NIAGARA MOHAWK POWER CORPORATION

DOCKET NO. 50-220

Proposed Changes to Technical Specifications (Appendix A)

FIGURE 6.2-1
NINE MILE POINT NUCLEAR STATION
MANAGEMENT ORGANIZATION CHART

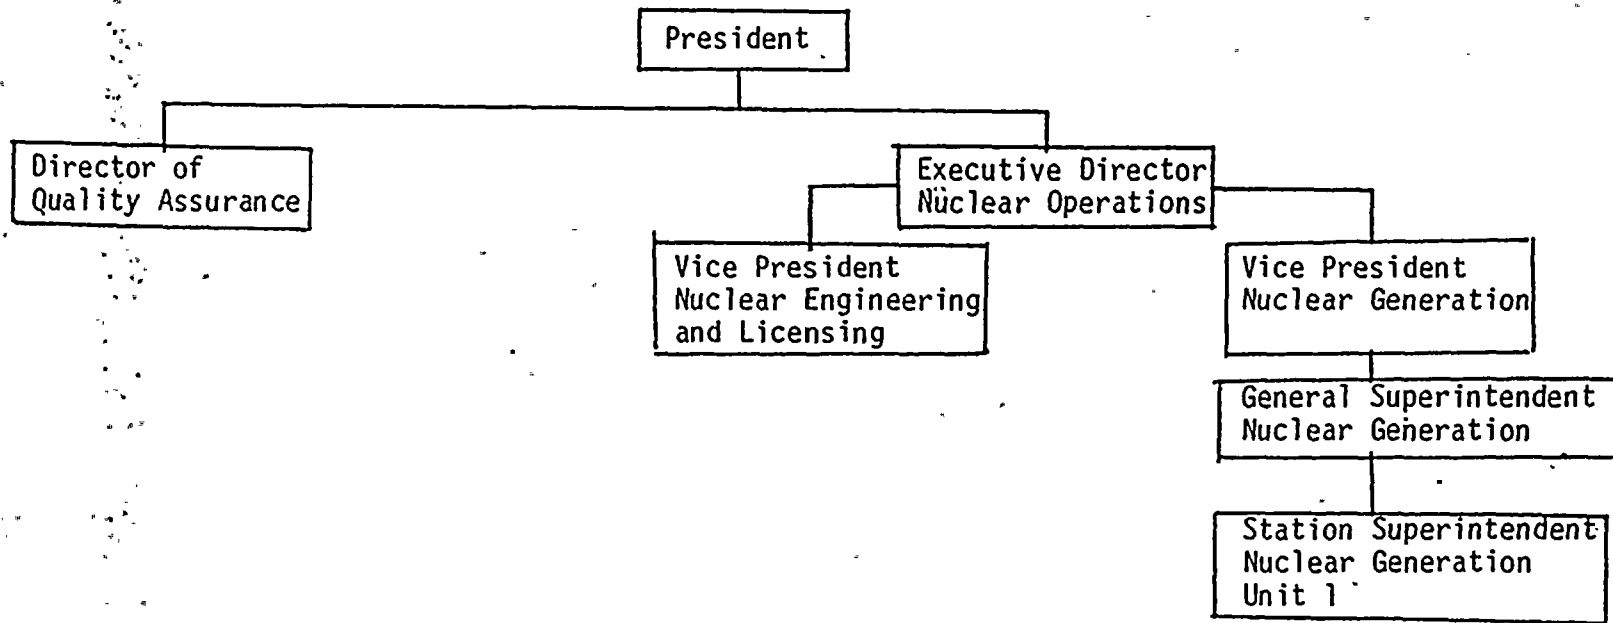
Replace page 246 with the attached revised page 246. This page has been entirely retyped with marginal markings indicating the change.

The changes in the Management organization chart are the result of Niagara Mohawk Power Corporation's determination to provide the highest level of management expertise and experience in the construction and operation of the Corporation's nuclear facilities and to insure that the goals of improved overall performance at Nine Mile Point Unit 1 and the successful completion of construction and initiation of reactor operation at Nine Mile Point Unit 2 are achieved.

In order to utilize the skill and knowledge of these individuals to enhance our management capability and at the same time maintain all authority and responsibility for Nuclear Construction and Operations within the Corporation's Management Structure, the Board of Directors of Niagara Mohawk Power Corporation has created the positions of Executive Director of Nuclear Operations and Director of Quality Assurance and has designated Mr. B.G. Hooten as Executive Director of Nuclear Operations and Mr. J.A. Perry as Director of Quality Assurance for Niagara Mohawk. As Executive Director of Nuclear Operations, Mr. Hooten assumes the functions formerly performed by the Senior Vice President, Nuclear Operations. Mr. Perry, as Director of Quality Assurance, assumes the functions performed by the Vice President of Quality Assurance.

By resolution of the Board of Directors, the Executive Director of Nuclear Operations has been vested with the authority and responsibility to oversee and direct the Corporation's Nuclear Operations, including the authority and responsibility to plan and provide policy direction and coordination of all major activities of the following company functions: nuclear engineering and licensing, nuclear electric production and the construction of company nuclear facilities -- it being the intent of the Corporation that the Executive Director of Nuclear Operations represent the Corporation as if he were an officer thereof. By the same resolution of the Board of Directors, the Director of Quality Assurance has been vested with the authority and responsibility to oversee and direct the Corporation's quality assurance program with full authority to bind and act on behalf of the Corporation as if he were an officer thereof.

As a result of the delegation of authority and responsibility by the Board of Directors, the positions of Executive Director of Nuclear Operations and Director of Quality Assurance possess the essential attributes of their antecedent offices and possess the authority of officers of the Corporation. The changes therefore have no safety or environmental significance.
